**Service Letter #:** SL14-6647111

**Part/Assembly #:** 66-47111 Check Valve, Hydraulic Hand Pump Aerocet Model 1500 Floats.

**Subject:** Product Improvements on Aerocet Check Valve, Hydraulic Hand Pump P/N 66-47111.

**(Fig.1)**

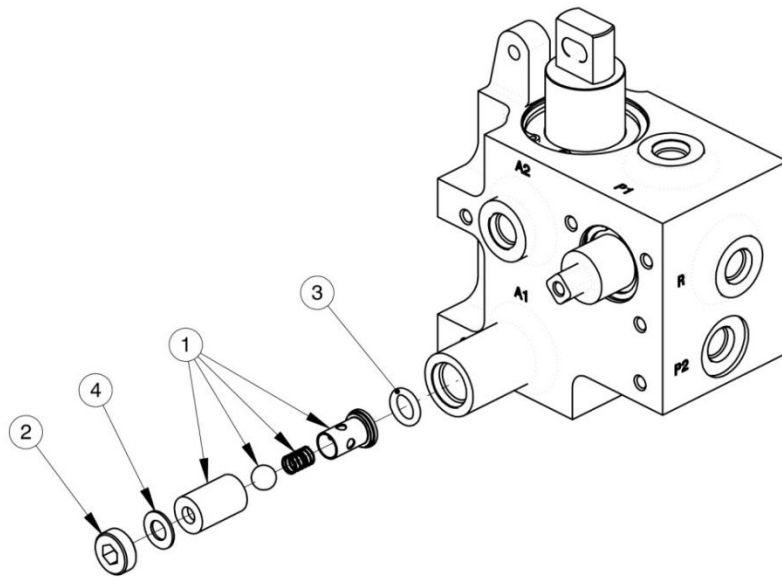
This design change is intended to enhance the function and operation of the Check Valve in the Hydraulic Hand Pump, Core Block Assembly.

Replace 66-47108 Check Valve, Cartridge, Hydraulic with 66-47111 Check Valve, Hydraulic Hand Pump as shown in (Fig 1).

- 1) Remove hydraulic line that connects the hand pump to the reservoir assembly.
- 2) Remove the hydraulic fitting on the pump.
- 3) Use 1/4" allen wrench and remove set screw behind the inlet fitting.
- 4) Use a small pick or equivalent and remove flat washer, check valve cartridge, and o-ring seal.
- 5) Apply a light film of lithium grease to o-ring seal, and position in bore. Install new check valve cartridge, oriented as shown in (Fig. 1).
- 6) Install flat washer and secure all components with retaining nut. (Do not overtighten).
- 7) Refill hydraulic fluid reservoir as required. Cycle gear up and down without pressurizing multiple times or until all air is purged from the system.
